# Illinois Department of Transportation

SUBJECT: FAI Route 80/94  
Section 2626.2 R-2  
Cook County  
Contract No. 62114  
Item No. 4P, December 16, 2005 Letting  
Addendum A

Attached is an addendum to the plans or proposal. This addendum involves revised and/or added material.

1. Revised Table of Contents.
2. Revised pages 2 – 3, 10 – 12, 30, 51 – 58, 106 – 109, 115 – 124, 152, 167 – 168 and 362 – 363 of the Special Provisions.
3. Added pages 482 - 506 to the Special Provisions.
4. Revised pages 2, 6, 7, 10, 14, 19 and 22 of the Schedule of Prices.
5. Revised sheets 3, 6 – 10, 13, 194, 362 and 364 of the Plans.
6. Added sheet 362A to the Plans.

**EMERGENCY ACCESS DOOR**  
TOP VIEW

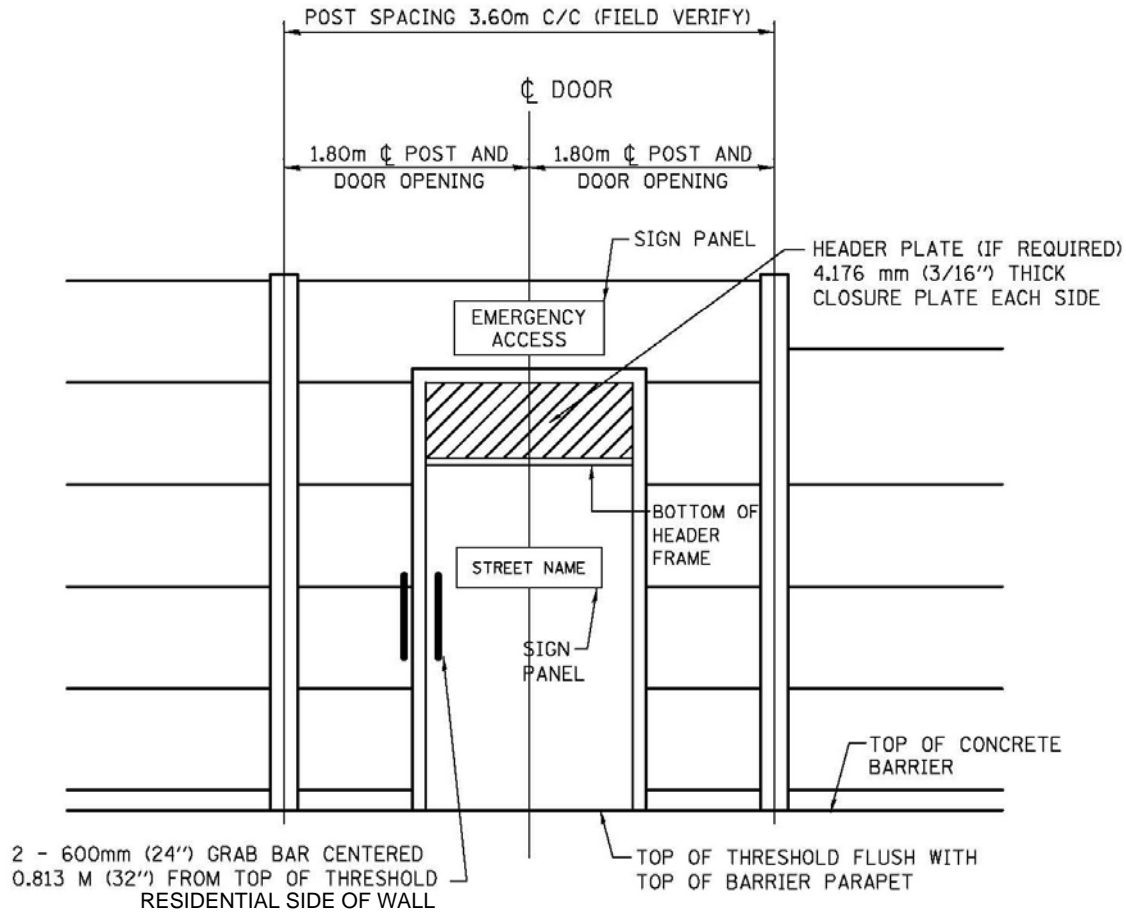
Signing at each emergency access door: The Contractor shall furnish the signs, which are shown on the table included herein and shall install them on the noise wall or access doors as detailed in the plans.

**EMERGENCY ACCESS DOOR**  
TOP VIEW

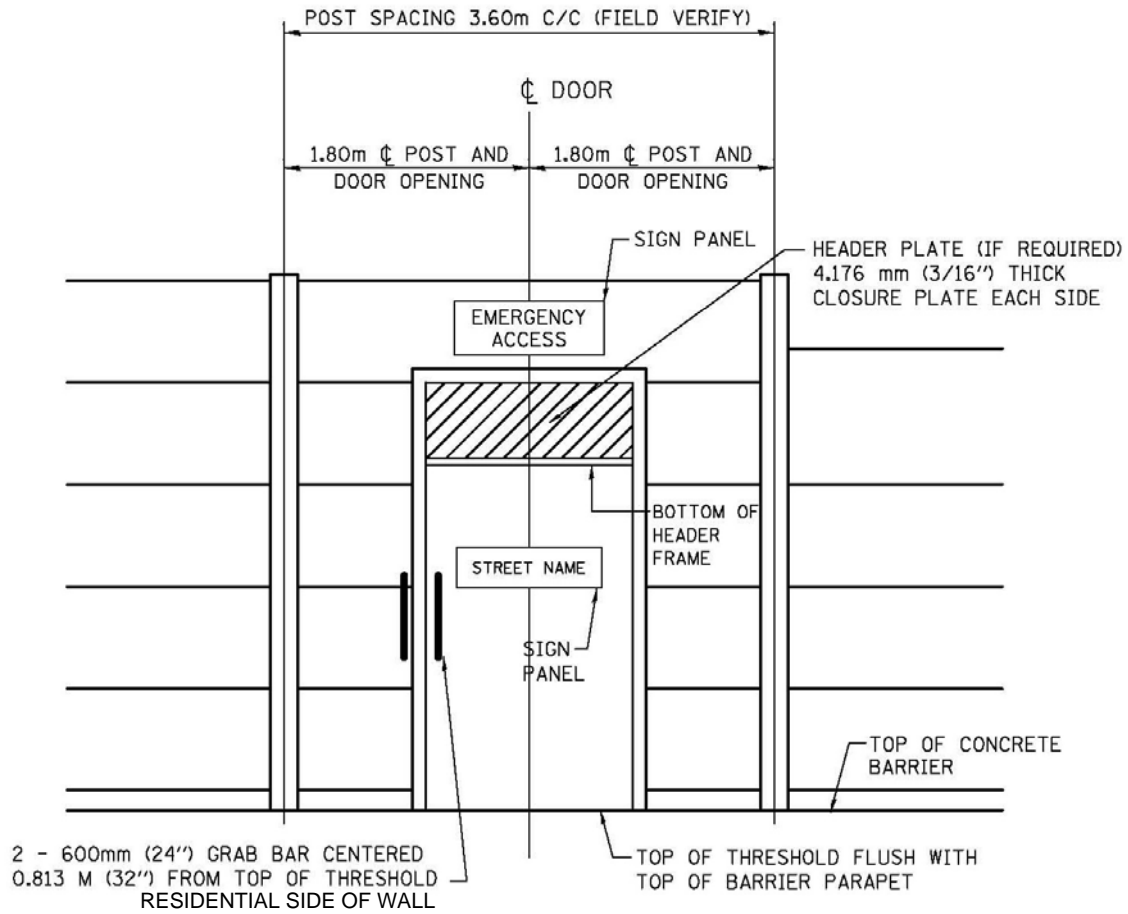
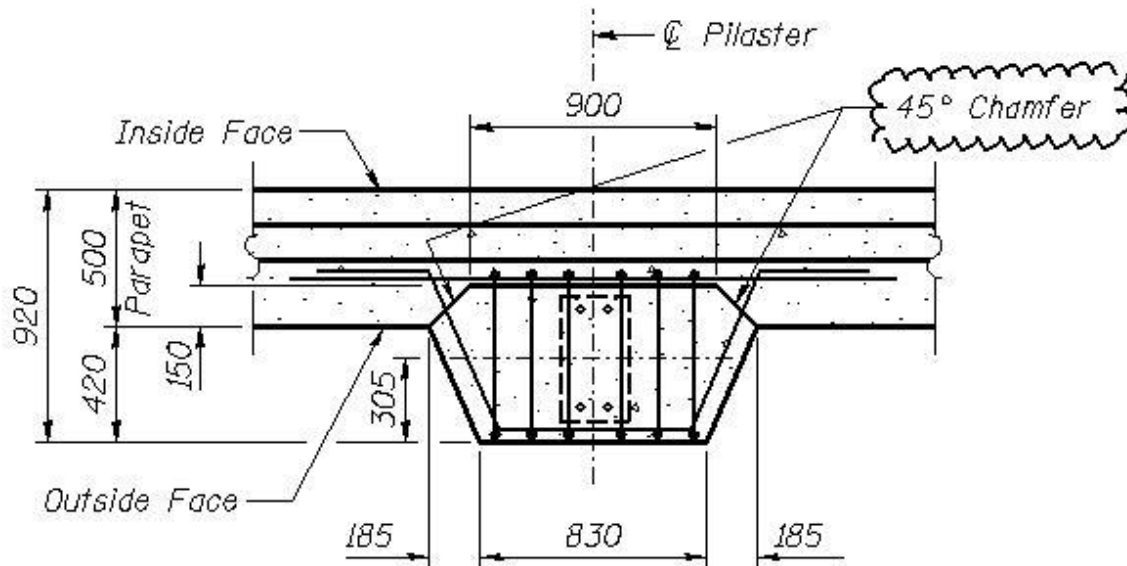
Signing at each emergency access door: The Contractor shall furnish the signs, which are shown on the table included herein and shall install them on the noise wall or access doors as detailed in the plans.
